STAFF REPORT

CITY OF COLUMBUS PLAN COMMISSION (February 12, 2025 Meeting)

Docket No. / Project Title: PUDF-2025-001 (Westwood Market)
Staff: Noah Pappas

Request Summary:

SHEET TITLE:	BUILDING SECTIONS & TRASH ENCLOSURE	COLUMBUS	COLUMBUS TOWNSHIP	BARTHOLOMEW CO.	INDIANA
WESTWOOD MARKET					
4325 W. JONATHAN MOORE PIKE, COLUMBUS, IN 47201

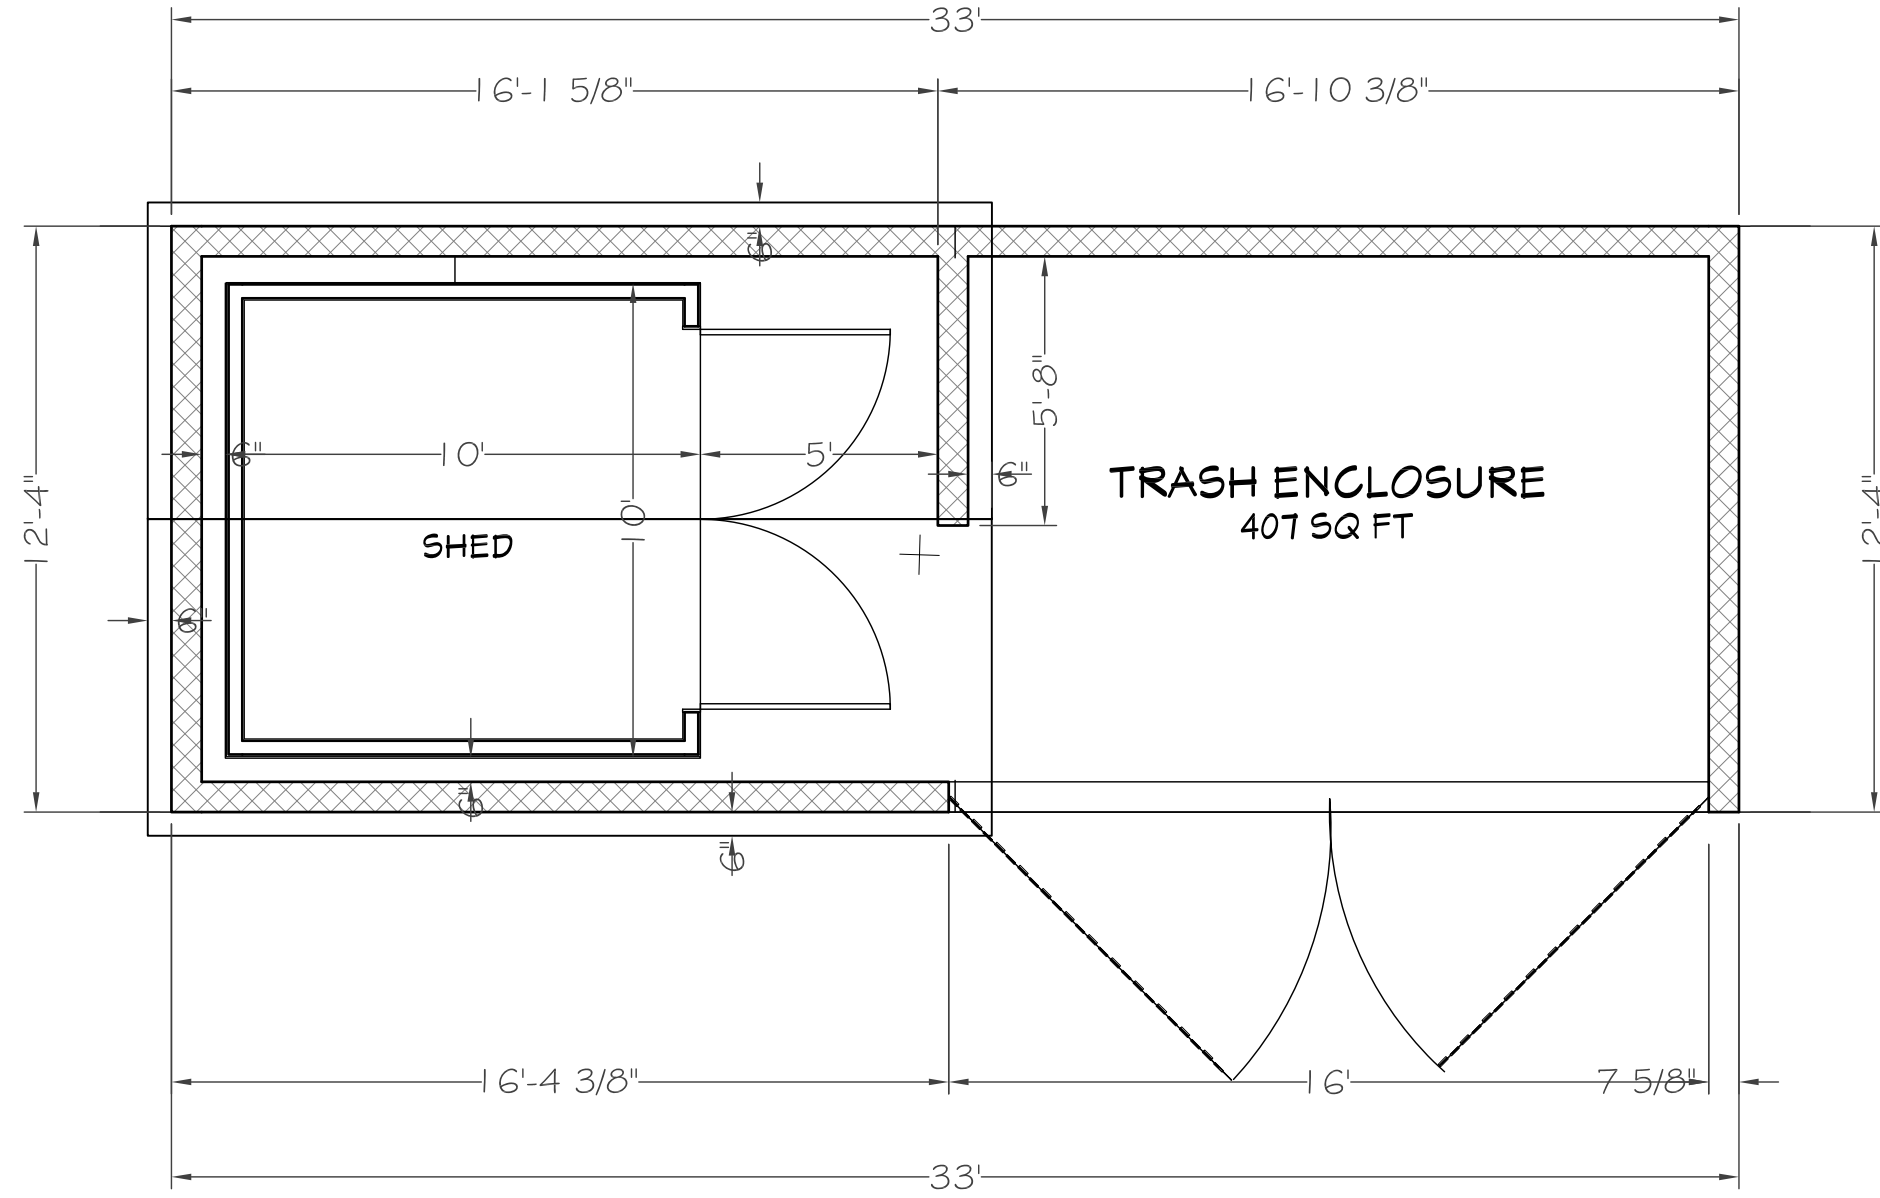
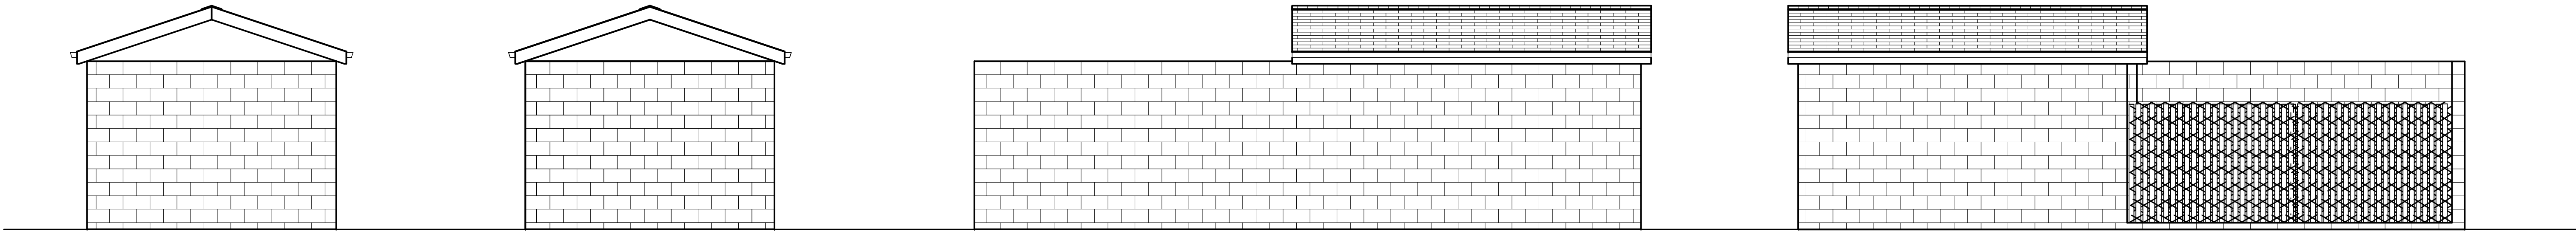
4. An elevation drawing of the proposed gas station canopy shall be provided, with exterior materials labeled.
 5. The trash enclosure / shed elevation drawings shall be made consistent with the site plan and all exterior materials shall be labeled. Also, the mesh gate provided for the dumpster enclosure shall

be replaced with one of wood or vinyl that provides the 100% opacity specified by the Zoning Ordinance.

Trash Enclosure:		Unidentified stone enclosure with non-100% opaque wire mesh gate.	None.	<u>Section 6.1(C)(2):</u> Screening shall consist of a 6 foot tall, 100% opaque fence of wood, stone, masonry, architectural metal, or other similar construction.
